Item #1:
Report Of AC Meeting - April 15, 2013
Double G's Restaurant Changes

AGENDA
ARCHITECTURAL COMMISSION
REGULAR MEETING
Monday, April 15, 2013 at 7:00 P.M.

TO: Village President and Village Board
FROM: James M. Hogue, Village Planner
DATE: April 17, 2013
RE: Board & Commissions Report for 4/23/13

ITEM #2: For the ARCHITECTURAL COMMISSION on MONDAY, April 15th @ 7:00 P.M.

SITE PLAN
PARKING LOT EXPANSION
DOUBLE G'S ROADHOUSE

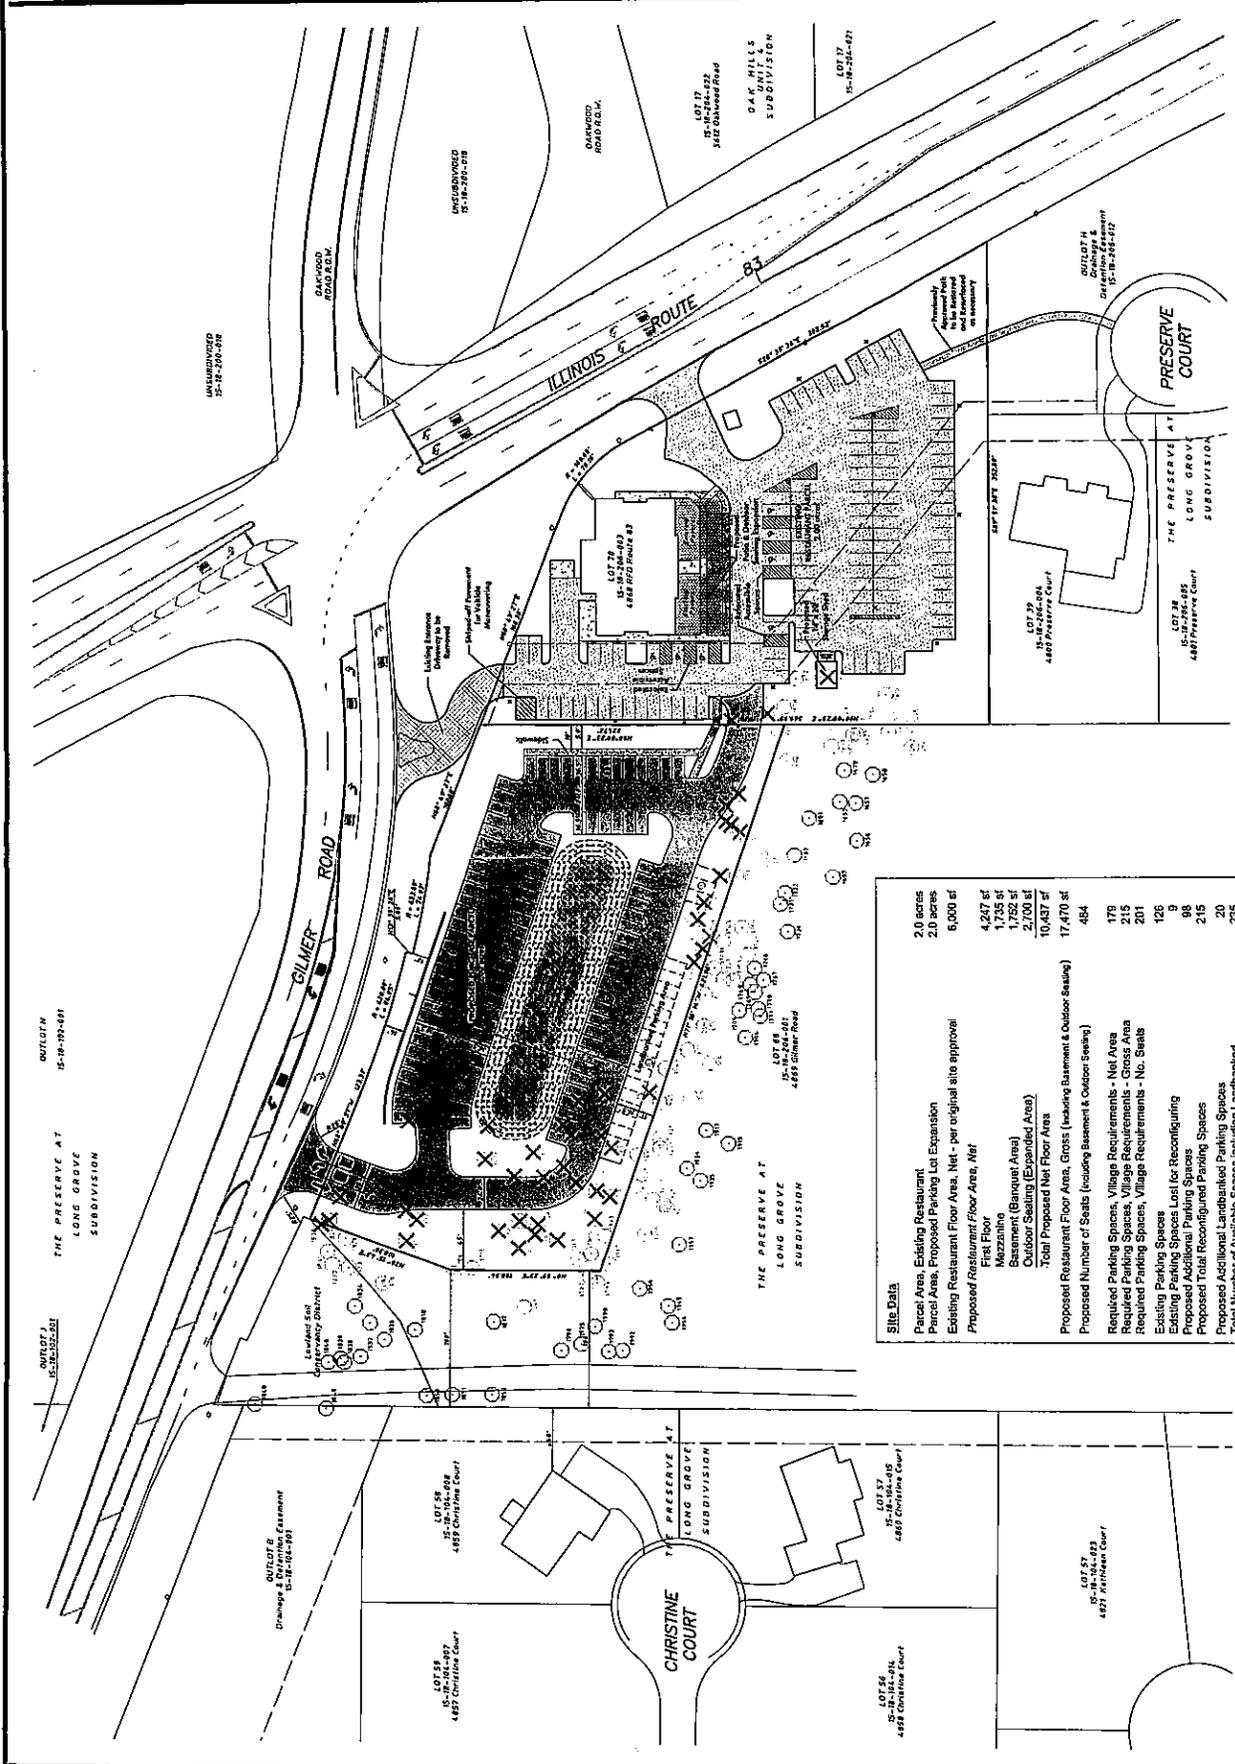
- Site Plan – Overall the reaction to the site plan as proposed was positive. The AC noted the plan was well thought out with regard to neighboring properties and provided good access (both internal and external) to the site as well as provide needed parking for the restaurant use. A motion was made by Commissioner Tapas, seconded by Commissioner Plunkett to accept the site plan as prepared by Haegar Engineering dated 4.10.13 and presented to the AC on 4.15.13. The motion was approved subject to the following conditions;
 - 1) Plans for the proposed 14' x '20 shed shall be brought back to the AC including material samples, colors, shingles and other specifications of the structure for further review and consideration.

The petitioner and their consultants met with the property owners to the west on April 9th in response to Condition #1 as recommended by the PCZBA. The result of this meeting is a slightly reconfigured parking area than was initially proposed (attached). Proposed parking remains the same just configured a bit differently. This was done to minimize impacts to trees on site as well as address and further minimize impacts on properties to the west.

- 2) The Village Engineer shall review and verify that the proposed detention area\bio-swale does not create a flooding or “overtop” situation in the parking area during a 100 year storm event.
